Addendum No. 2

FRIENDSHIP FOREST WILDLIFE SANCTUARY

PARK RENOVATION

Double Leg Pedestal (DLP)

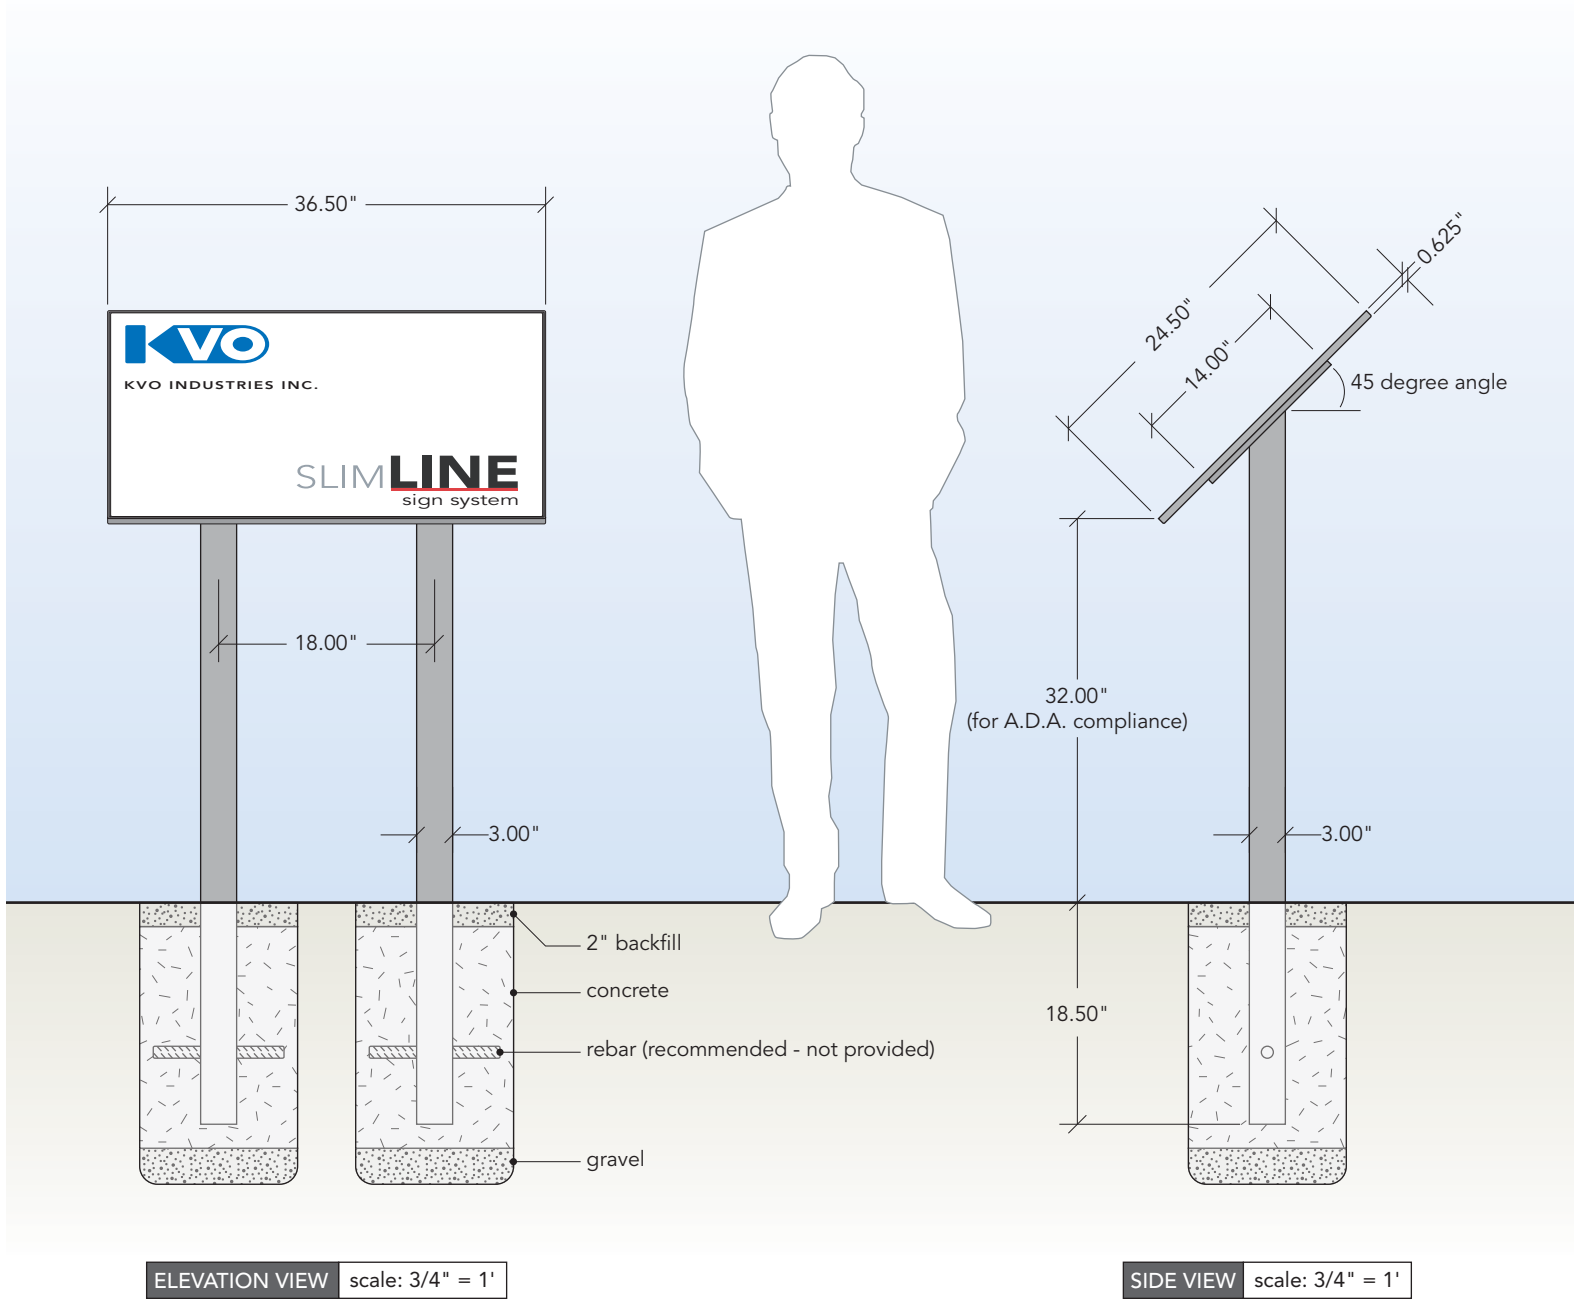
On bid form, under section "Site Elements" on page 18, item number "48", it calls out for "Interpretive Signage with Frame/Stands" (QTY.10). I found (QTY.2) details #4, labeled "Message Sign Detail" on plan page "A3.1" is that the correct detail for the "Interpretive Signage with Frame/Stands"? If yes, where are they located on the plans and how many of each type of "Interpretive Signage with Frame/Stands" there on the plans?

Please refer to the attached cut sheet. Only the pedestals/frames are to be purchased (QTY – 10). No “wording” or other interpretative language/details are to be included as a component of the pedestals
